Vogtle Electric Generating Plant Units 1&2  
Docket Nos. 50-424, 50-425

Subject: License Amendment Request: Revise Technical Specification 3.7.2 Limiting Condition for Operation to Remove One Main Steam Isolation Valve System

Enclosure: Evaluation of Proposed Changes  
Attachment 1: Proposed Technical Specification Changes (Marked-up Pages)  
Attachment 2: Revised Technical Specification Pages  
Attachment 3: Proposed Technical Specification Bases Changes (Marked-Up) for  
Information Only

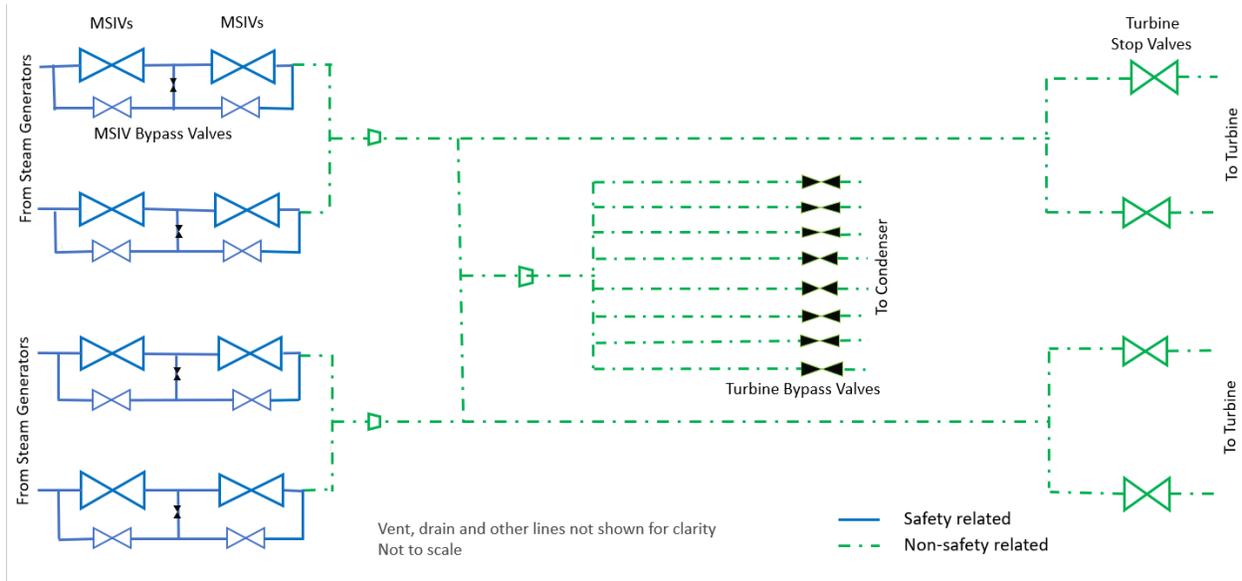
Each main steam line contains two MSIVs in parallel with two MSIV bypass valves. These valves isolate the secondary side of the steam generators to deal with leakage and malfunction and to prevent the uncontrolled blowdown of two steam generators and isolate non-safety-related portions of the main steam system. This constitutes the design function of the main steam isolation system.

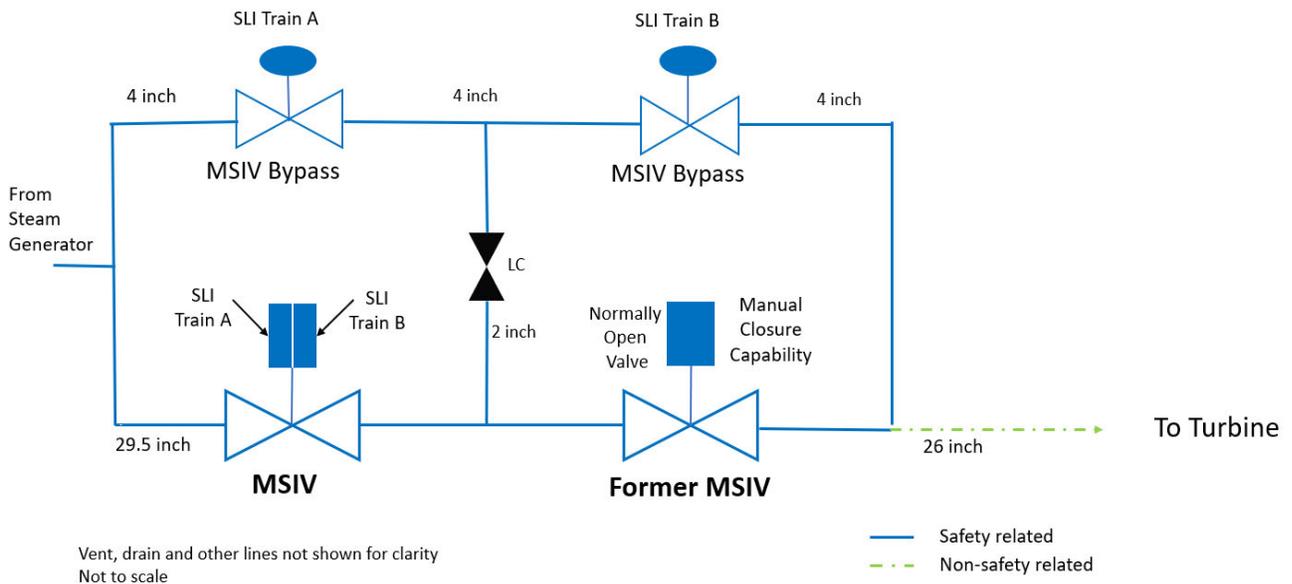
To better understand the proposed TS changes, the Figure below shows the change in the physical plant that supports the proposed TS changes. There will no longer be MSIV systems. Each main steam line will have one MSIV with a dual train actuator. Two bypass valves remain in each main steam line, each closed by a different train of the SLI signal.

The LCO is changed from two MSIV systems per steam line to four MSIVs and their associated actuator trains and associated bypass valves. There are four main steam lines in each VEGP unit. This equates to one MSIV and associated components per main steam line. The Applicability exception is changed to reflect the change from two MSIV systems per steam line closed to one MSIV and one bypass valve per steam line closed. An MSIV system currently consists of an MSIV and its associated bypass valve. The plant condition of the Applicability remains the same, as each steam line is isolated by an MSIV and at least one bypass valve.

Figure 8. Keep Open Schematic

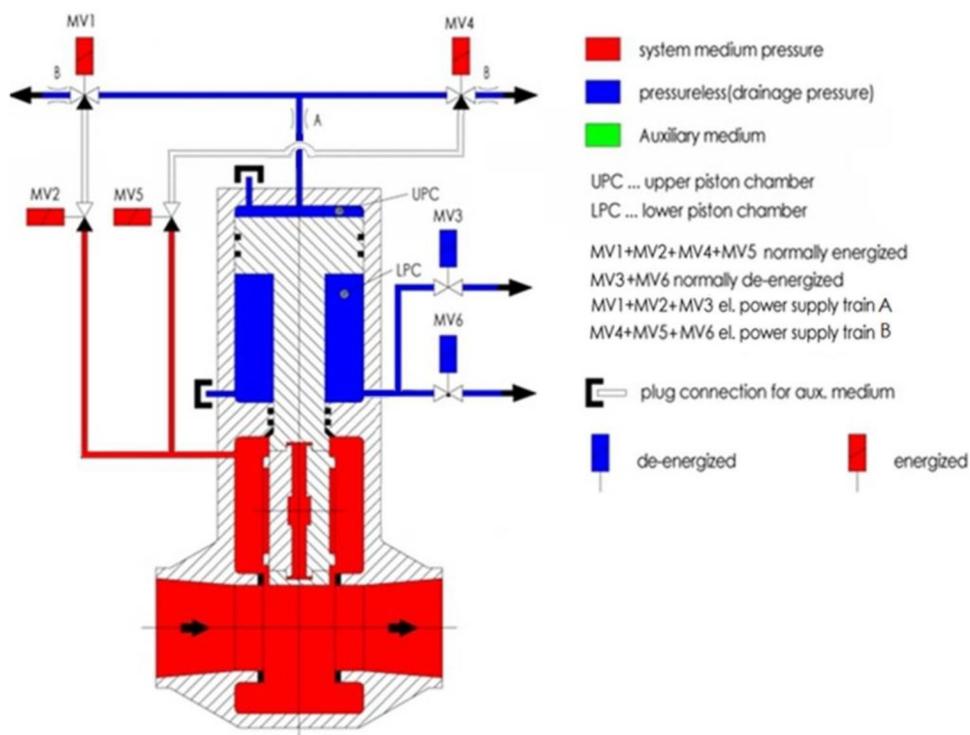
The output from these isolation signals is supplied to the solenoid valves that operate the actuator. SLI-A actuates the A train of solenoids and SLI-B actuates the B train solenoids. Each set of solenoids causes the actuator to operate, independent of the other set of solenoids. Either train A or B of the actuator is capable of causing the actuator to close the MSIV in the time assumed by the safety analysis.
